SUBJECT: Addendum No. 4

REFERENCE: Invitation To Bid (ITB) for the IAH Term C Helix Ramp Bearing & Misc. Repairs at George Bush Intercontinental Airport; Solicitation No. H06-HELIXC-2024-006; Project No. 235A

IAH Term C Helix Ramp Bearing & Misc. Repairs at George Bush Intercontinental Airport

NORTH
 SHEET No.: A1-101B
 SCALE:
 IAH TER C GARAGE LEVEL 7 WEST SIDE
 FLOOR PLAN

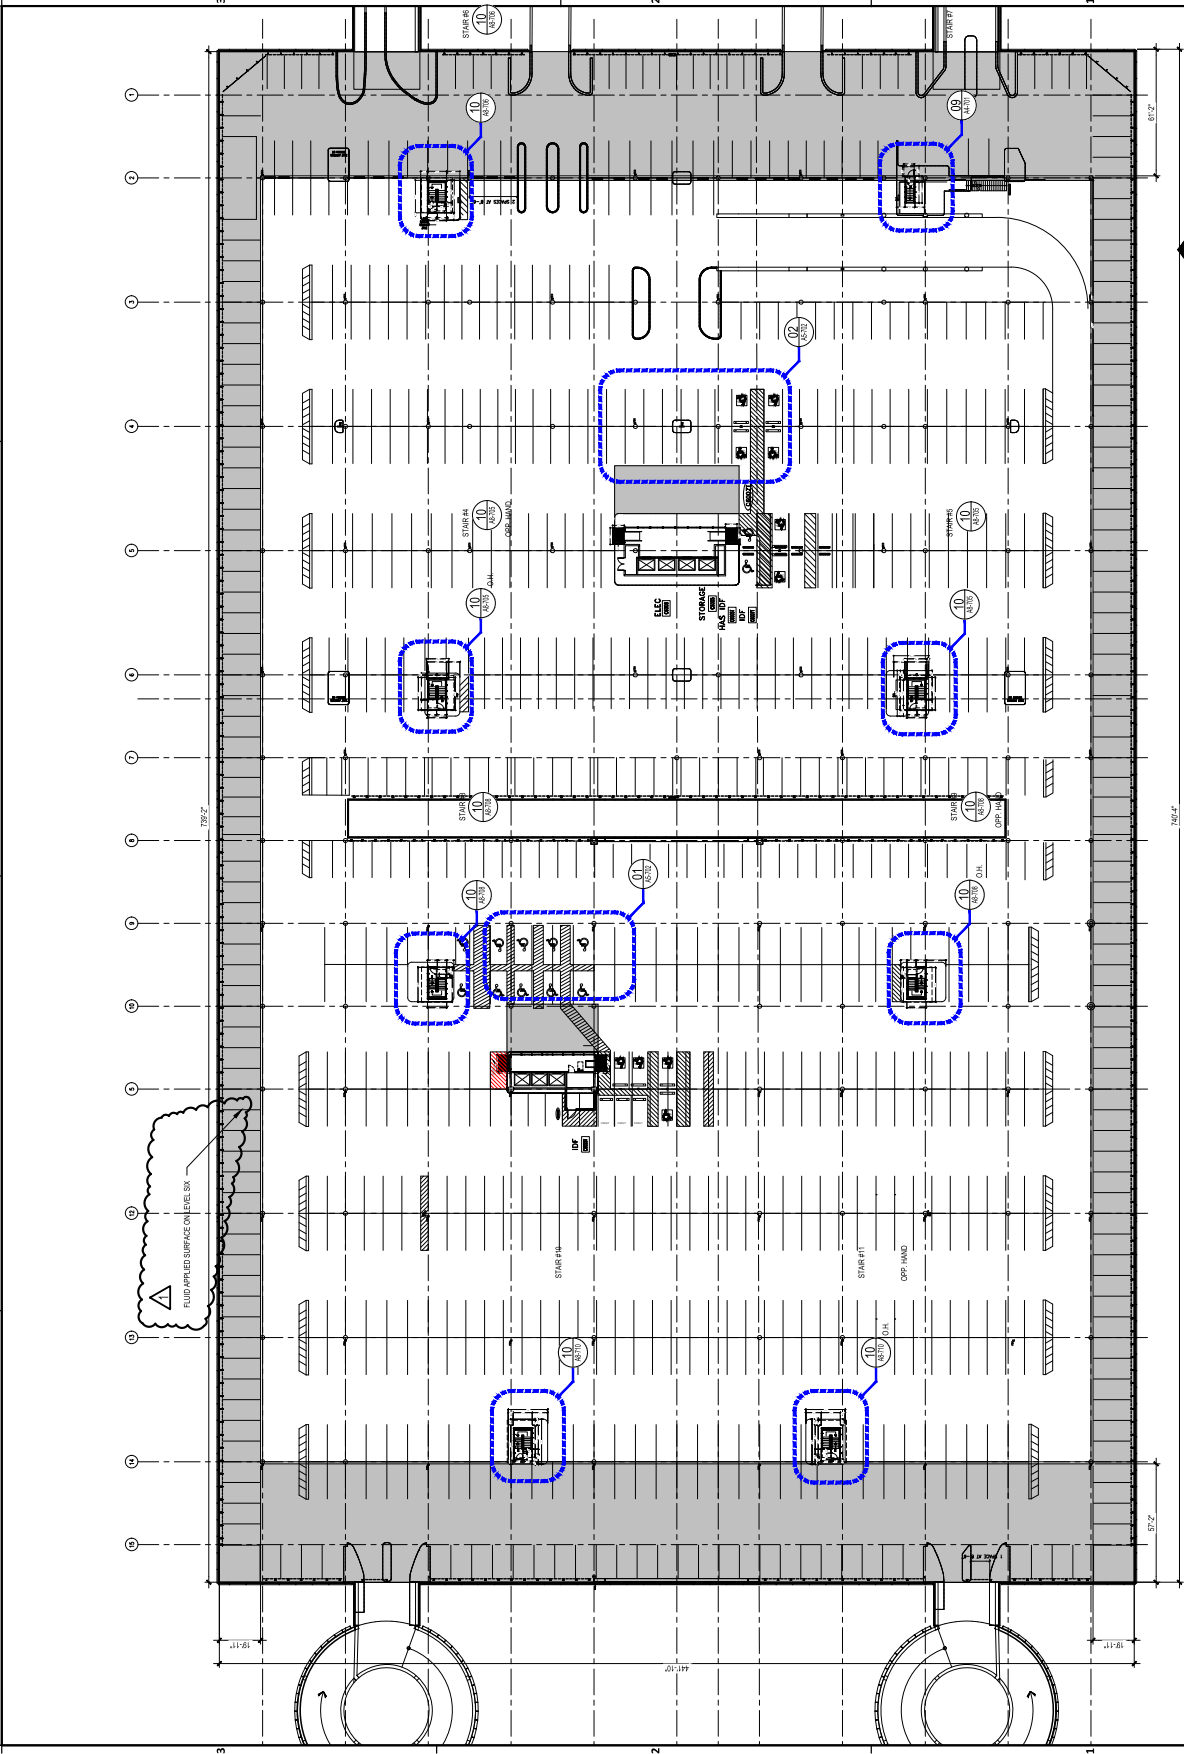
6. **Question:** Sheet A1-701B provides the sheet/detail callouts for the stair tower curtain wall enclosures. Stair Tower #7, 10 and 11 reference sheet A4-701. This sheet is not in the documents and has not been issued with Addendum 1 or 2. Sheet A1-701B was also not corrected in this regard in Addendum 1 or 2. Please advise.

7. **Question:** Note: it appears that Stair Towers 10 and 11 should have been labeled A8-710 instead of A4-701 as A8-710 has drawings/details pertinent to towers 10 and 11.

22. **Question:** Pertaining to the Bid Form - Part B; For Bid Item #1, the specified deck costing system is called out to be installed on the garage ramps (6ea x 32' x 80' = +/-30,000 sf), where are the additional install areas?

Response: Sheet A7-01B has been modified to give the correct enlarged plan location.

Response: Sheet A7-01B has been modified to give the correct enlarged plan location.

Response: The fluid applied area includes uncovered surfaces on level 6 which are not covered by the level 7 deck. See Sheet A1-701B for shaded areas to receive fluid applied coating, which includes 14,000 sf for bridge conditions.

01 IAH TERMINAL C GARAGE LEVEL 4 WEST SIDE FLOOR PLAN
1" = 30'-0"

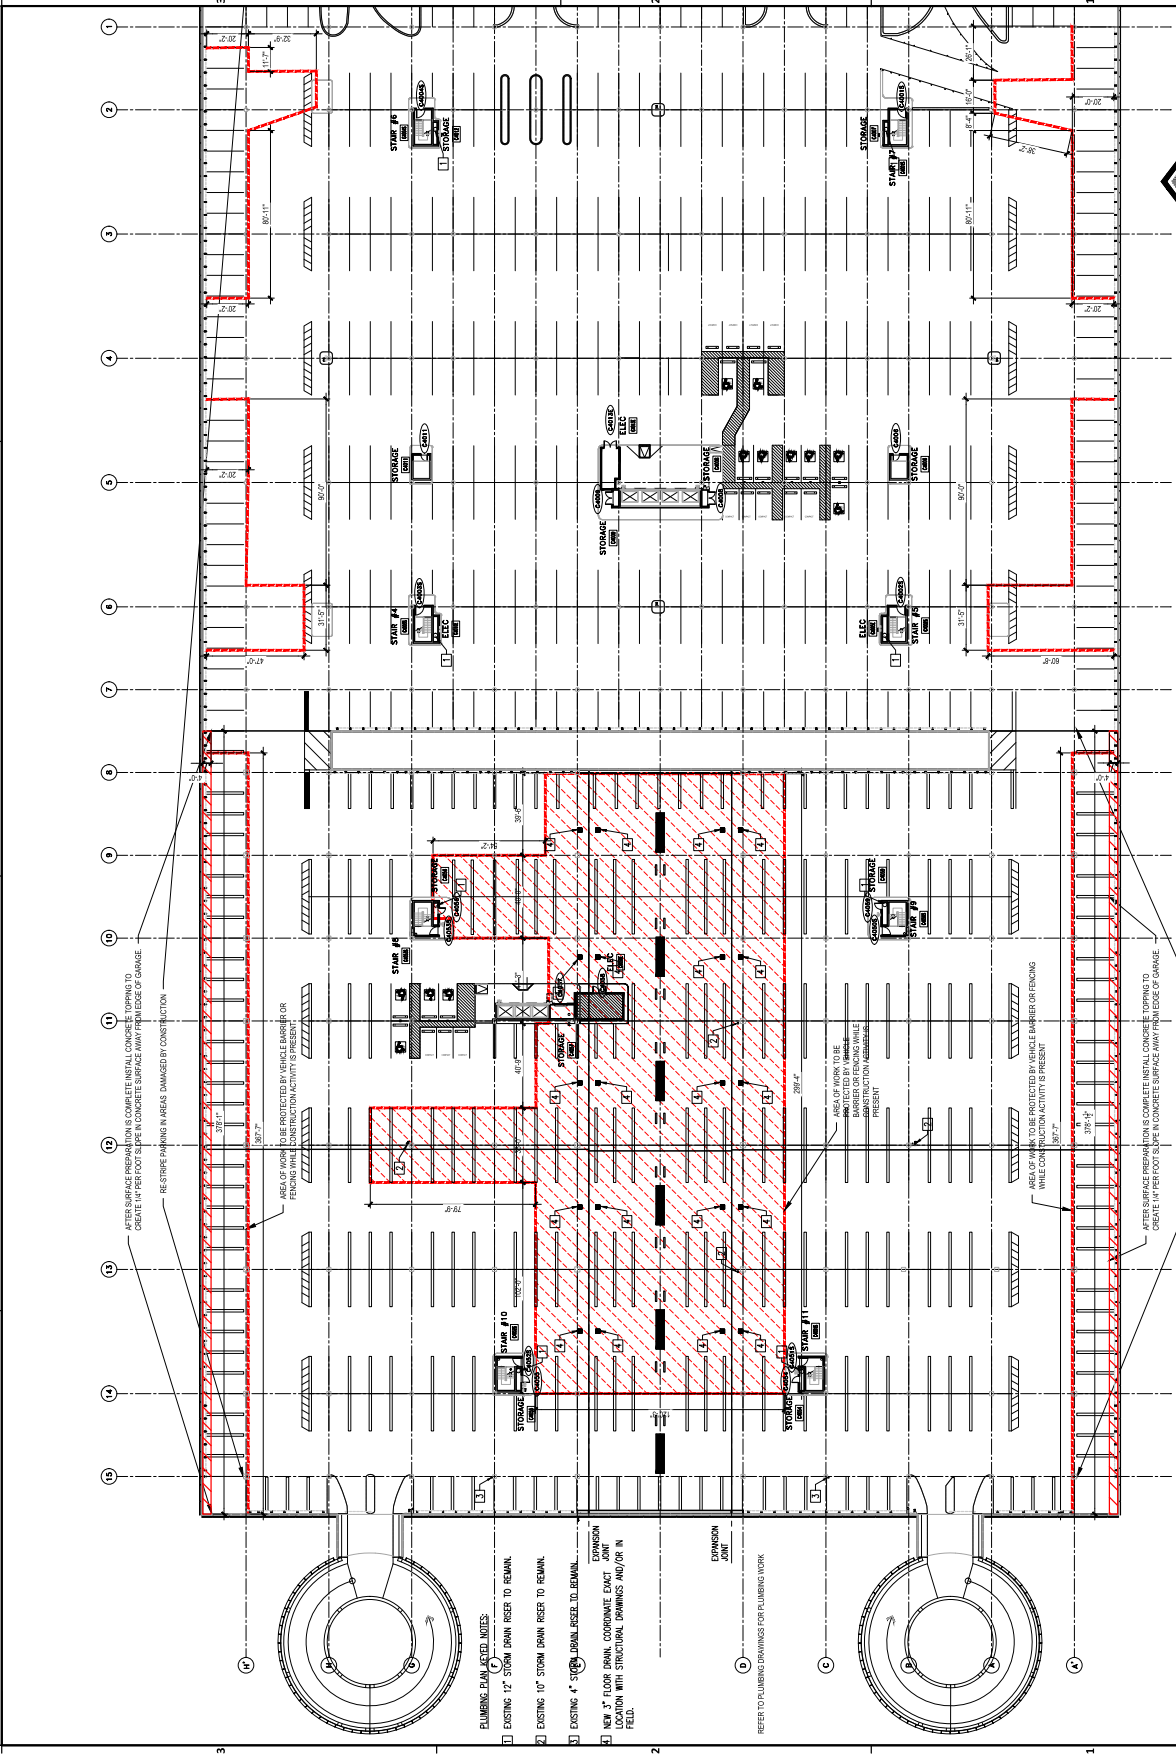
14. **Question:** The bid form indicates that there is 5,920 SF of concrete topping to slope away from the garage edge. The bid form stipulates that this is all allocated for level 6. The drawings show the same detail however on level 4. Cumulatively, by my calculations, the sloping square footage

should be approximately 10,095 SF across level 4 and level 6. Please advise and issue a new bid form or drawing if necessary.

Response: The fourth-floor garage does have the sloped topping but is limited to the western half garage only. The bid form has been modified to show a quantity of 8,940 sf. Re: A1-401B modified to the dimension area. The quantity of painted stripes was modified to include the additional work on level 4.

Terminal "C" NORTH
 SECTION - ELEVATION - PLAN AT
 STAIR 07
 SCALE: AS-BUILT

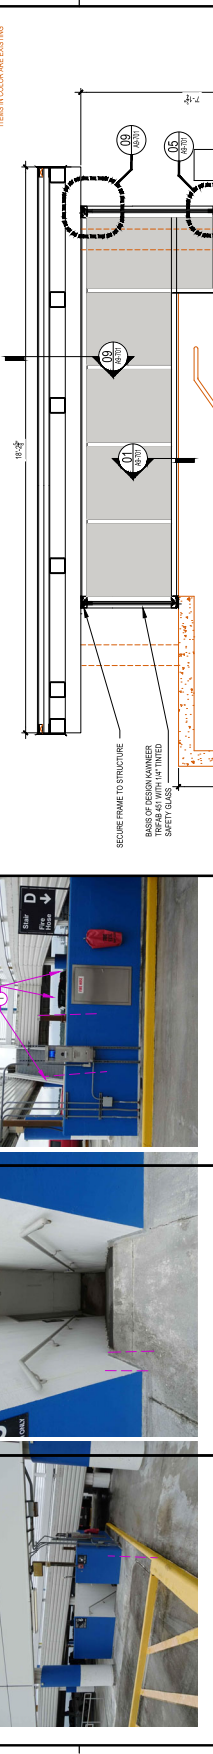
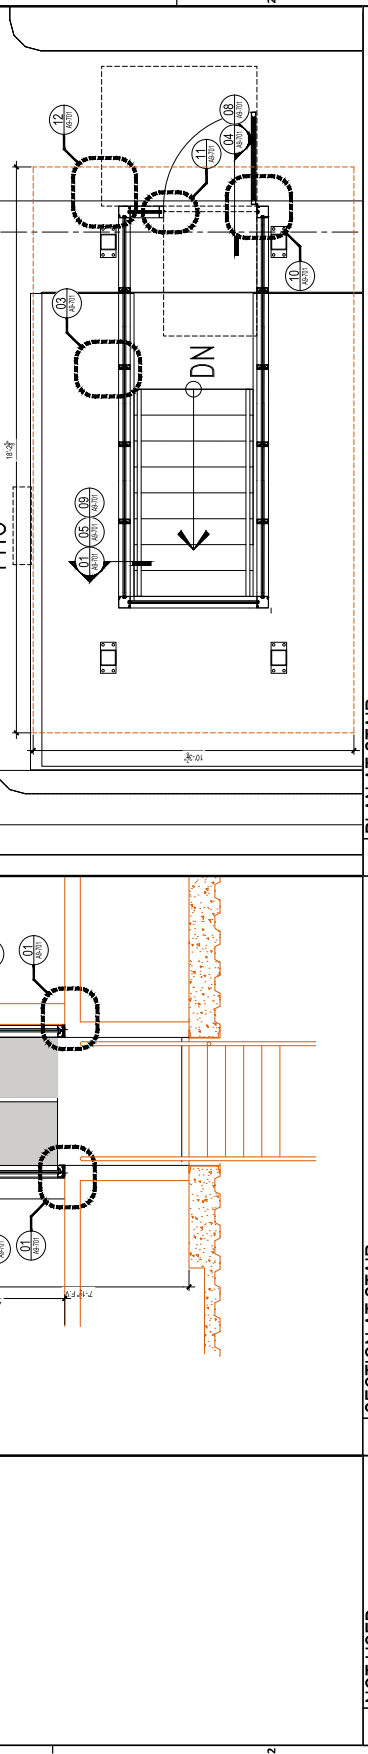
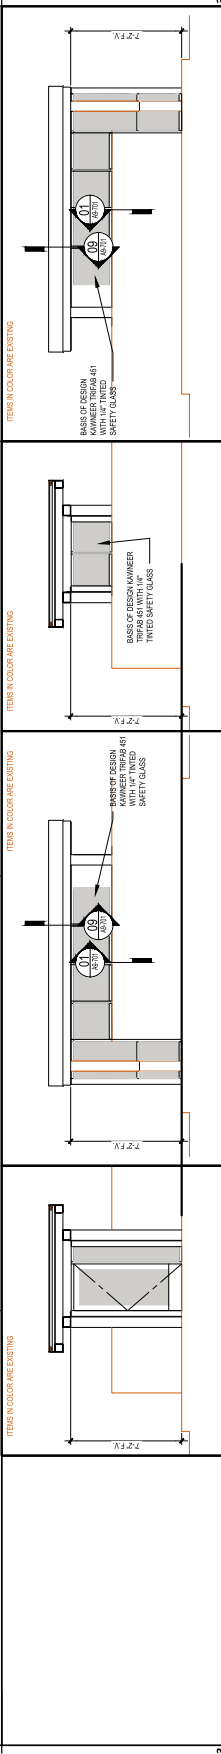
23. **Question:** For Bid Items #6 & #7, the high pressure washing/coatings estimated quantity for the stairs guardrails and handrails seems excessive - landings and stairs for Stairways 2,3,4,5,6,8,9,10 &11 (9ea x 3000 sf = +/-27,000 sf), Stairway #1 (+/- 2,000 sf), not including guardrails and handrails, if stairway walls are to be repainted add an additional +/- 68,000 sf. Is Stairway #7 to be included (not shown)? Please verify and confirm.

Response: Stairway # 7 is included. See Sheet A8-707 attached to this addendum.
